Access Compliance Report

Public Rights-of-Way

Intersection ID: 3564	Main Street: TAVERNAY_PY	Cross Street: TAVERNAY_PY	Location:	N
ADA ID: 0DE4F48C2ED8	Ramp Type: Perp	Initial Pass/Fail: Fail	Overall Compliance: No	Severity Score: 1.25
Codes/Mitigation Info/Possible Solution		Field Measurements/Component Compliance

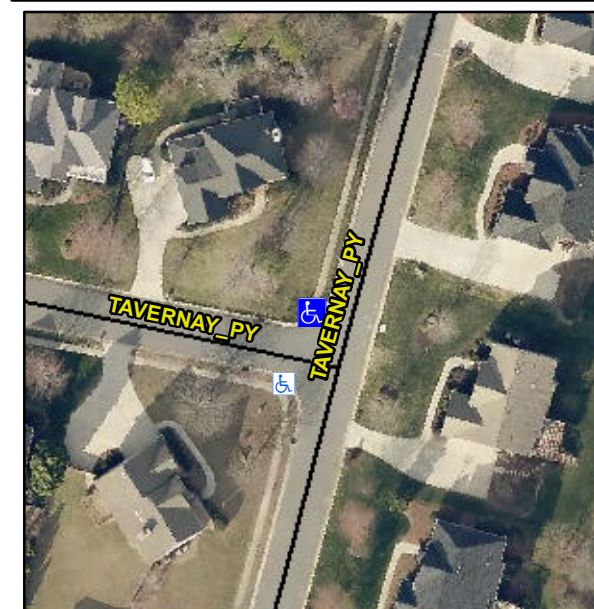
Not Found, R304.5.3

Compliance	Description	Data	Compliance	Description	Data
N/A	Ramp Length (in)	48.0	Yes	Ramp Slope (%)	5.0
Yes	Ramp Width (in)	48.0	No	Ramp XSlope (%)	3.0
N/A	Flare Type LT	N/A	N/A	Flare Type RT	N/A
N/A	Flare Slope LT (%)	N/A	N/A	Flare Slope RT (%)	N/A
N/A	Flare Traversable LT?	N/A	N/A	Flare Traversable RT?	N/A
N/A	Landing Length (in)	N/A	N/A	DWS Provided?	N/A
N/A	Landing Width (in)	N/A	N/A	DWS Contrast?	N/A
N/A	Landing Slope (%)	N/A	N/A	DWS Length (in)	N/A
N/A	Landing X Slope (%)	N/A	N/A	DWS Full Width?	N/A
N/A	Landing Curb? (Y/N)	N/A	N/A	DWS Offset (in)	N/A
N/A	Shared Landing?	N/A			
N/A	Gutter Ponding?	N/A	N/A	Gutter Slope (%)	N/A
N/A	Gutter Lip Ht (in)	N/A	N/A	Gutter X Slope (%)	N/A
N/A	Painted X Walk1?	No	N/A	Painted X Walk2?	N/A
	X Walk 1 Direction	To SW		X Walk 2 Direction	N/A
N/A	X Walk 1 Width (in)	N/A	N/A	X Walk 2 Width (in)	N/A
	X Walk 1 Slope (%)	0.7		X Walk 2 Slope (%)	N/A
	X Walk 1 X Slope (%)	2.1		X Walk 2 X Slope (%)	N/A

Remove & Replace Entire Ramp.
